MACK SUBDIVISION

Engineering Comments: FINAL PLAT COMMENTS (should be addressed prior to submitting the FINAL PLAT for review and/or signature by the City Engineer):

APPLICATION NUMBER 5 DATE November 1, 2018

DETAIL SITE PLAN

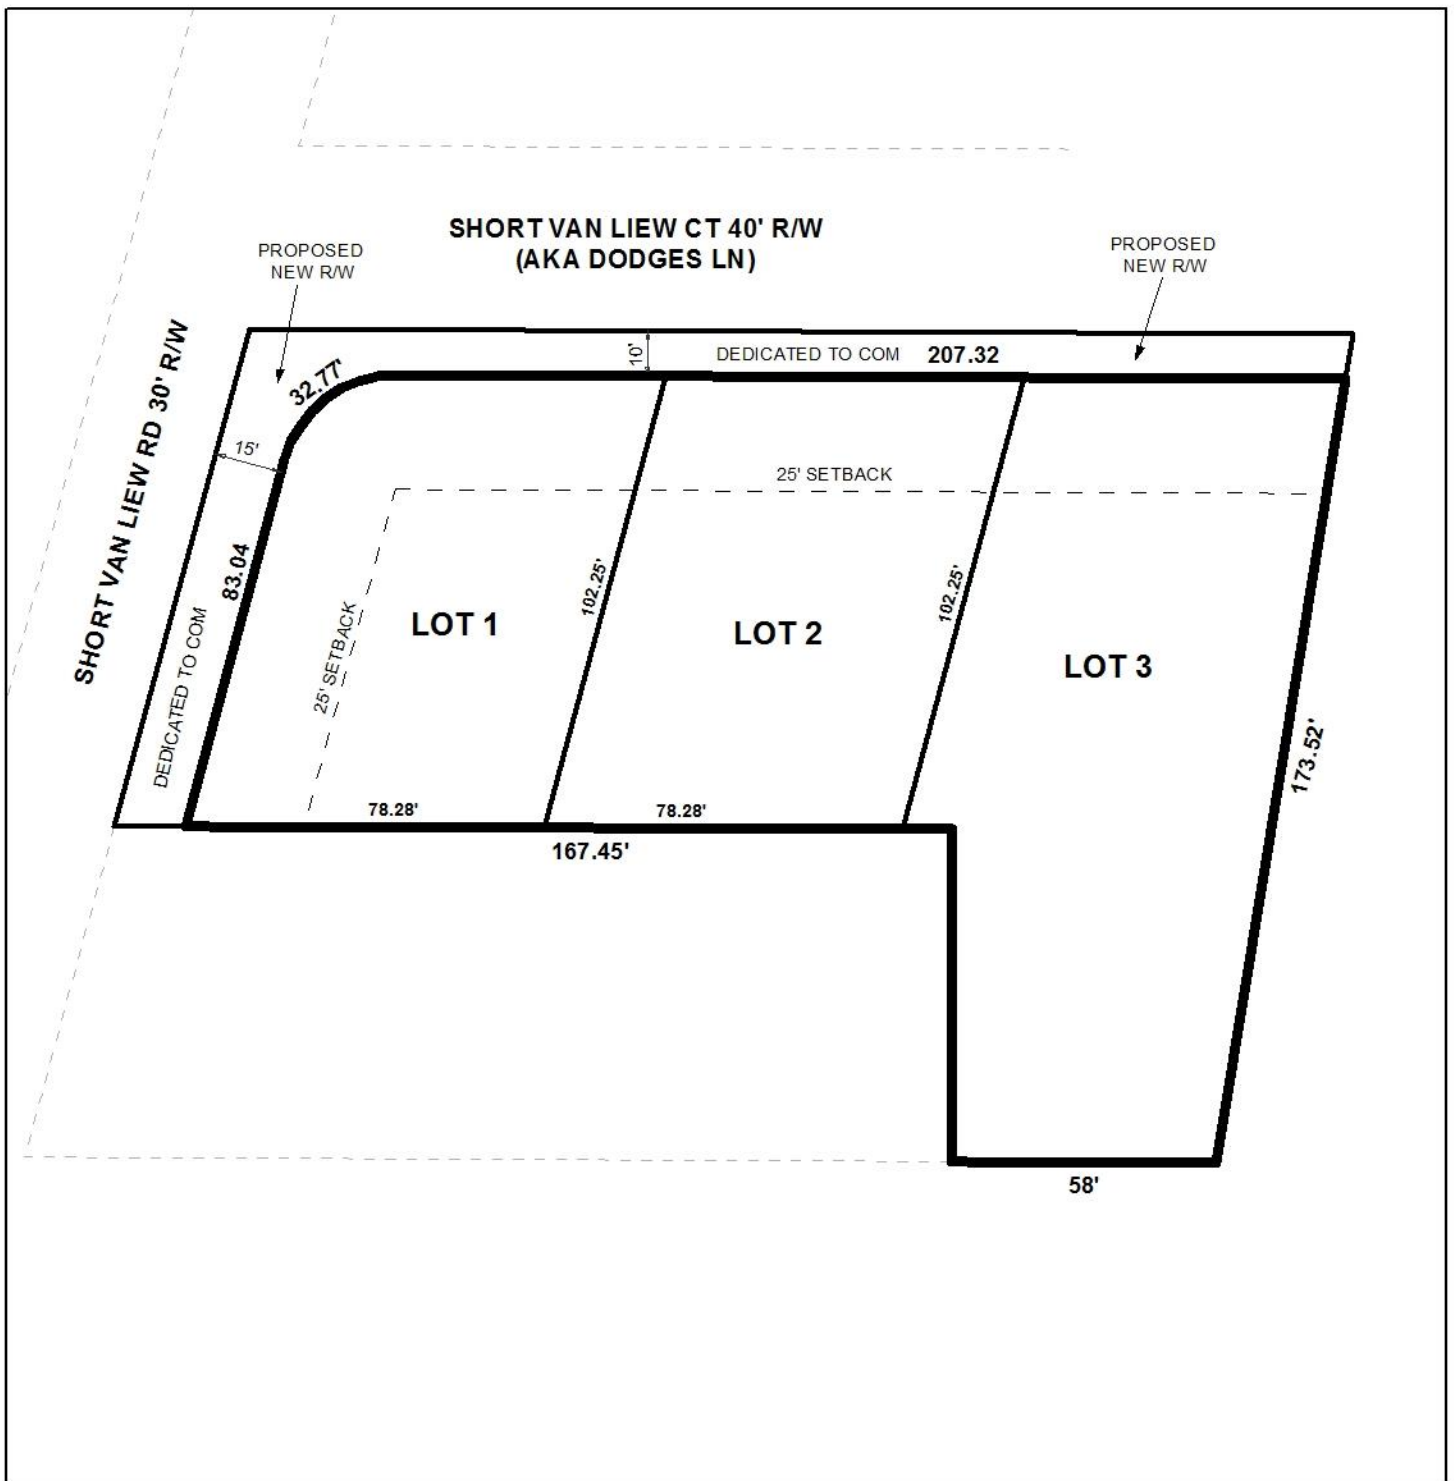
- A. The ADECA Office of Water Resources (OWR) web site indicates that the future flood zone boundaries may be located within this proposed subdivision.

- B. Provide all of the required information on the SUBDIVISION PLAT (i.e. signature blocks, signatures, certification statements, written legal description, required notes, legend, scale, bearings and distances) that is required by the current Alabama State Board of Licensure for Professional Engineers and Land Surveyors.

- C. Review and revise the written legal description and/or the bearing and distance labels because they do not match each other.
- D. Provide the Surveyor's, Owner's (notarized), Planning Commission, and Traffic Engineering signatures.

- E. Add a note to the SUBDIVISION PLAT stating that a Land Disturbance permit will be required for any land disturbing activity in accordance with Mobile City Code, Chapter 17, Storm Water Management and Flood Control; the City of Mobile, Alabama Flood Plain Management Plan (1984); and, the Rules For Erosion and Sedimentation Control and Storm Water Runoff Control.

- F. Add a note to the Plat stating that the approval of all applicable federal, state, and local agencies (including all storm water runoff, wetland and floodplain requirements) will be required prior to the issuance of a Land Disturbance permit.

- G. Add a note that sidewalk is required to be constructed, and/or repaired, along the frontage of each lot, or parcel, at time of new development or construction, unless a sidewalk waiver is approved.

- H. Add a note to the plat stating that all proposed detention facilities, common areas, and wetlands shall be the responsibility of the Property Owner(s), and not the responsibility of the City of Mobile.

- I. Add a note to the plat stating that all easements shall remain in effect until vacated through the proper Vacation process.
- J. Provide a copy of the FINAL SUBDIVISION PLAT to the Engineering Dept. for review. No signatures are required on this drawing.

Proposed Lot 1 has frontage on Short Van Liew Road and Short Van Liew Court, and proposed Lots 2 and 3 have frontage on Short Van Liew Court. Short Van Liew Road is a minor street without curb and gutter with a substandard 30' right-of-way. As a 60' right-of-way width is required for streets without curb and gutter, dedication would be required to provide 30' from the centerline of Short Van Liew Road. Short Van Liew Court is also a minor street without curb and gutter with a substandard 40' right-of-way. Therefore, dedication would also be required to provide 30' from the centerline of Short Van Liew Court. A 25' corner radius dedication would also be required at the intersection of both streets. As all necessary frontage and corner radius dedications are indicated on the preliminary plat, these should be retained on the Final Plat, if approved.

As on the preliminary plat, the 25' minimum building setback line should be retained on the Final Plat, as measured from any required dedication. The lot sizes in both square feet and acres should be retained on the Final Plat, or a table should be furnished on the Final Plat providing the same information.

- 1) dedication sufficient to provide to 30' from the centerline of Short Van Liew Road;
- 2) dedication sufficient to provide 30' from the centerline of Short Van Liew Court;

- 3) dedication sufficient to provide a 25' corner radius at the intersection of Short Van Liew Road and Short Van Liew Court;
- 4) retention of the 25' minimum building setback line on the Final Plat as measured from any required dedication;

- 5) retention of the lot size labels on the Final Plat, or the furnishing of a table on the Final Plat providing the same information;
- 6) compliance with the Engineering comments: *[FINAL PLAT COMMENTS (should be addressed prior to submitting the FINAL PLAT for review and/or signature by the City Engineer): A. The ADECA Office of Water Resources (OWR) web site indicates that the future flood zone boundaries may be located within this proposed subdivision. B. Provide all of the required information on the SUBDIVISION PLAT (i.e. signature blocks, signatures, certification statements, written legal description, required notes, legend, scale, bearings and distances) that is required by the current Alabama State Board of Licensure for Professional Engineers and Land Surveyors. C. Review and revise the written legal description and/or the bearing and distance labels because they do not match each other. D. Provide the Surveyor's, Owner's (notarized), Planning Commission, and Traffic Engineering signatures. E. Add a note to the SUBDIVISION PLAT stating that a Land Disturbance permit will be required for any land disturbing activity in accordance with Mobile City Code, Chapter 17, Storm Water Management and Flood Control); the City of Mobile, Alabama Flood Plain Management Plan (1984); and, the Rules For Erosion and Sedimentation Control and Storm Water Runoff Control. F. Add a note to the Plat stating that the approval of all applicable federal, state, and local agencies (including all storm water runoff, wetland and floodplain requirements)*
